CITY OF FRANKLIN
PLAN COMMISSION MEETING*
FRANKLIN CITY HALL COUNCIL CHAMBERS
9229 W. LOOMIS ROAD, FRANKLIN, WISCONSIN
AGENDA
THURSDAY, JANUARY 23, 2020, 7:00 P.M.

1. **WAUKESHA WATER UTILITY OUTFALL FACILITIES RELATED TO REQUIRED RETURN FLOW FOR SOURCING LAKE MICHIGAN WATER: RETURN FLOW PIPELINE TO THE LAKE MICHIGAN WATERSHED VIA THE ROOT RIVER IN THE CITY OF FRANKLIN.**

REPORT TO THE PLAN COMMISSION

Certified Survey Map, Comprehensive Master Plan Amendment, Rezoning, and Site Plan

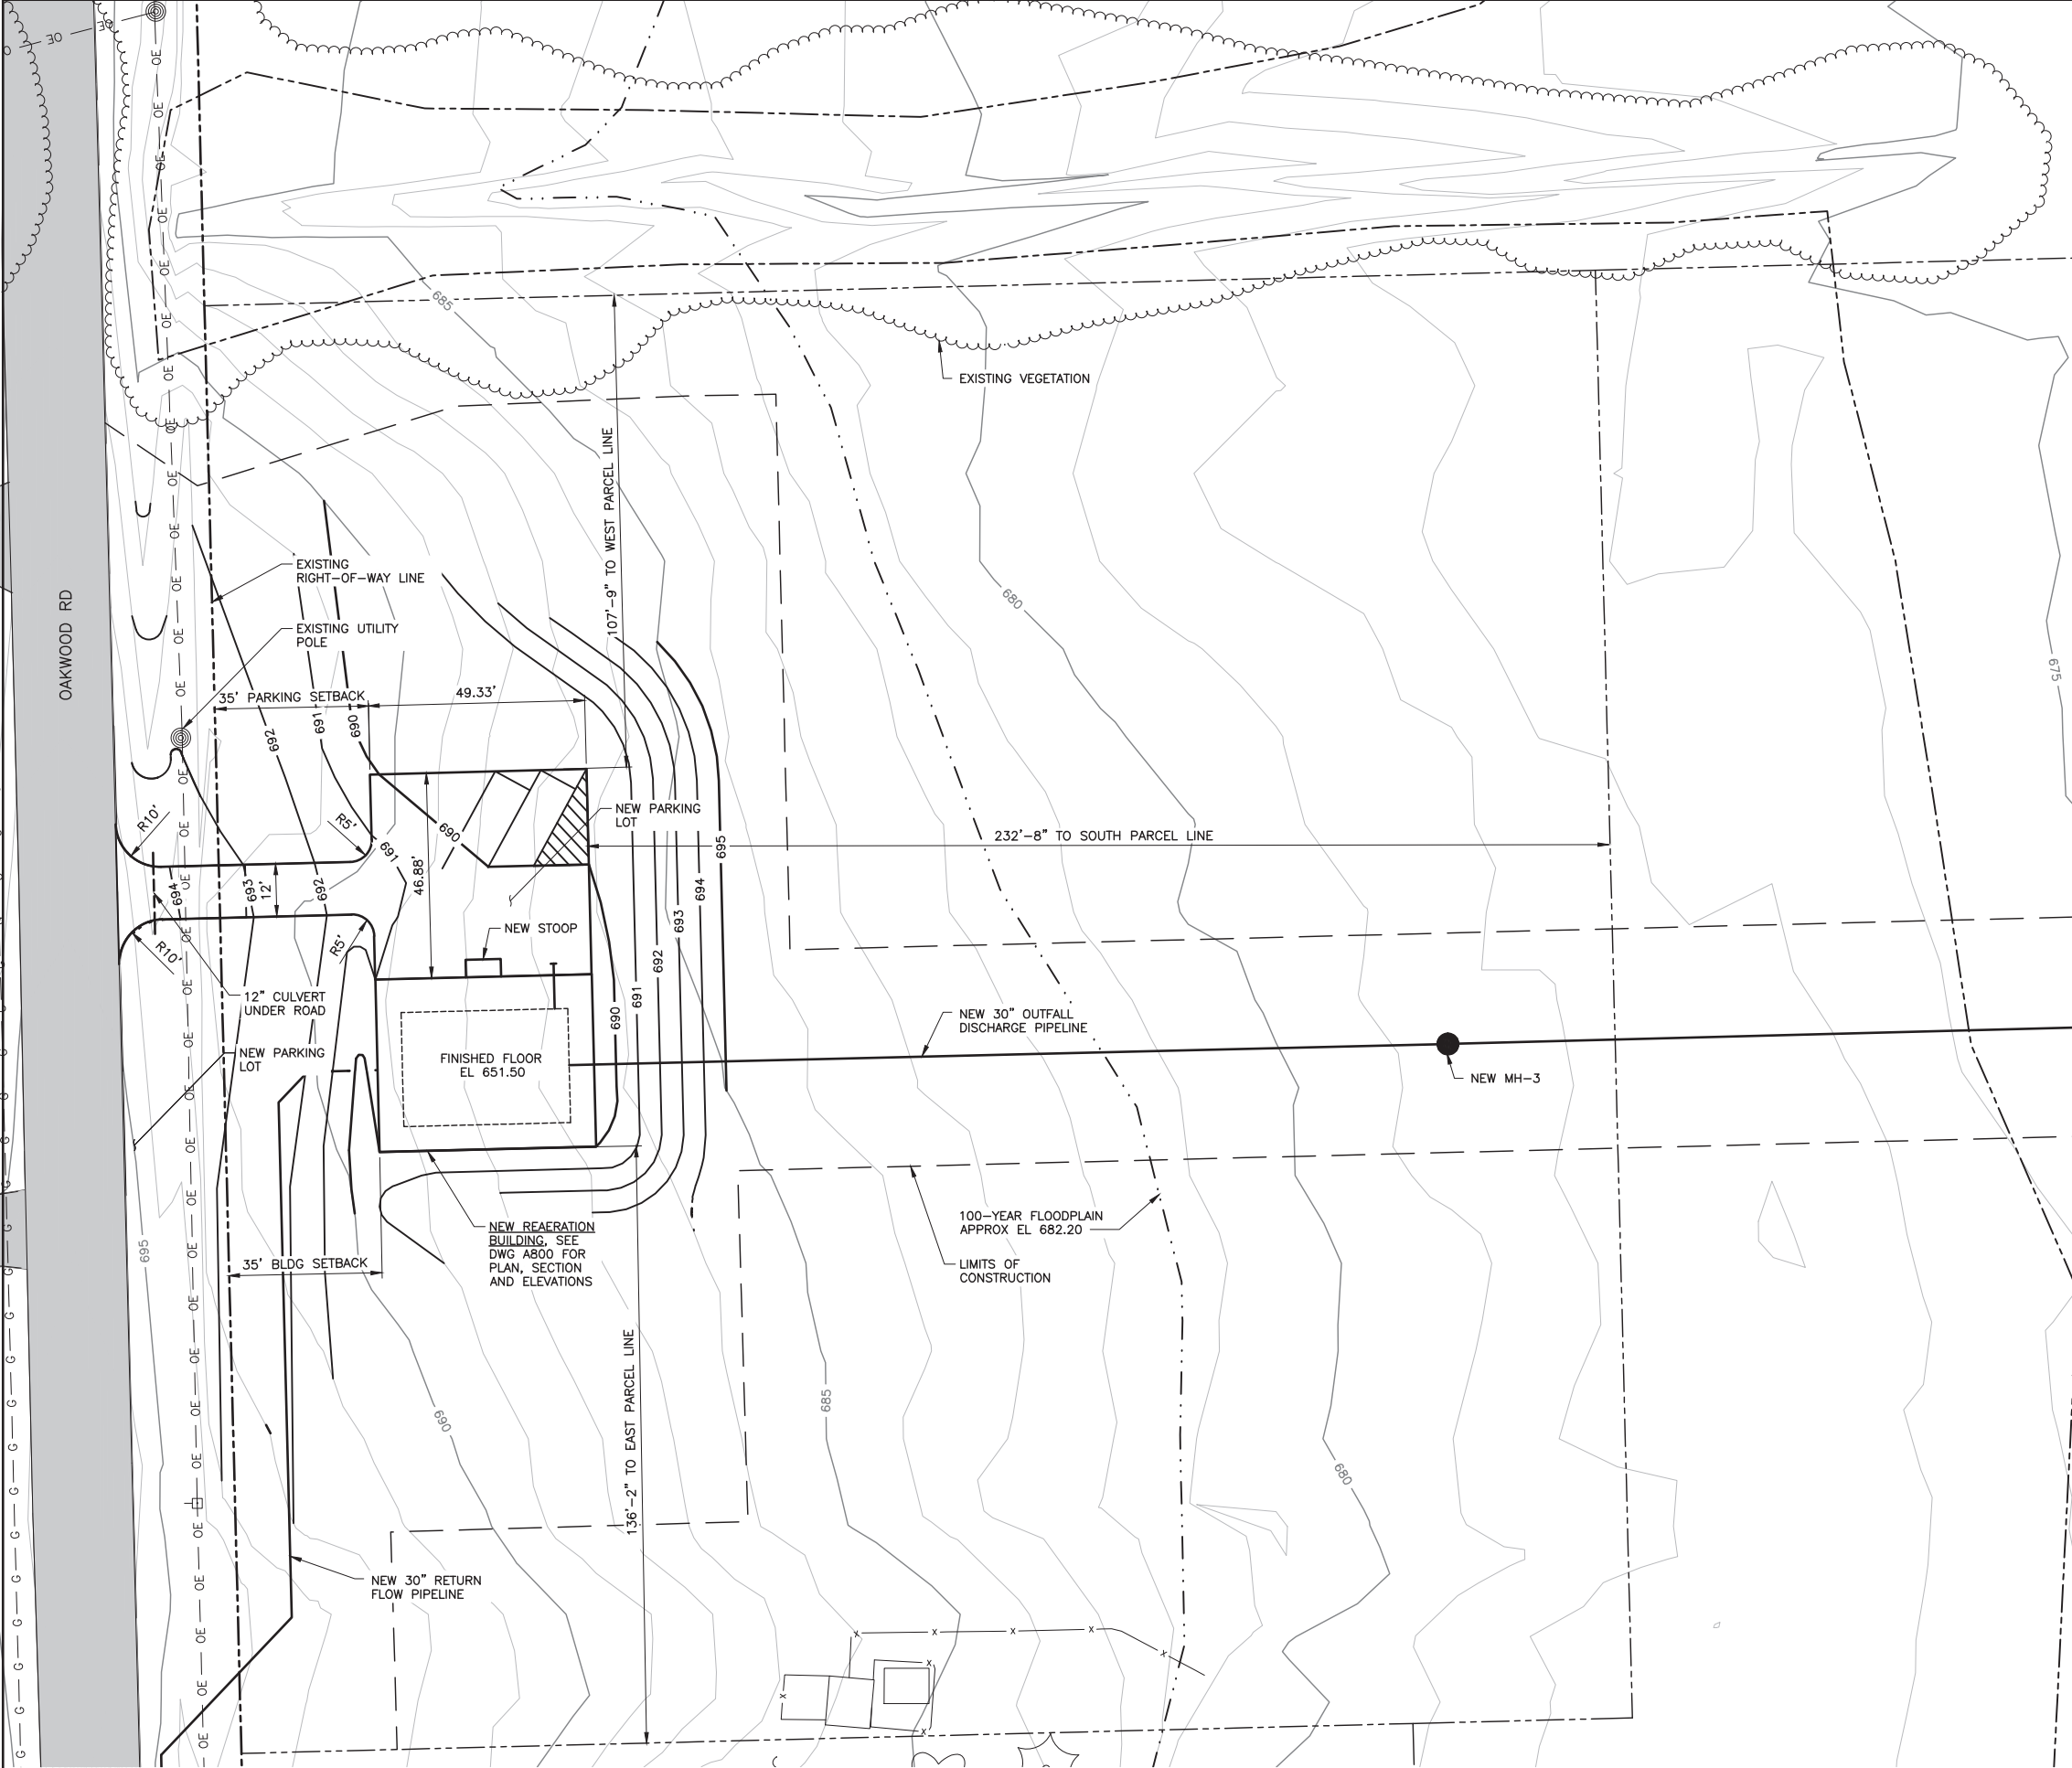
- N. **North Arrow.** North arrow. - - North arrow needed on Sheet SP-2.
 - BB. **Financial Plan for Project Implementation to be provided.** A financial plan for project implementation, acceptable to the Plan Commission. - - Only general total cost information is provided in project summary. Please provide a financial plan for project implementation.

- N. **North Arrow.** North arrow. - - North arrow needed on Sheet SP-2.

WWU Response: Parking lot and driveway dimensions are shown on drawing SP-2 .
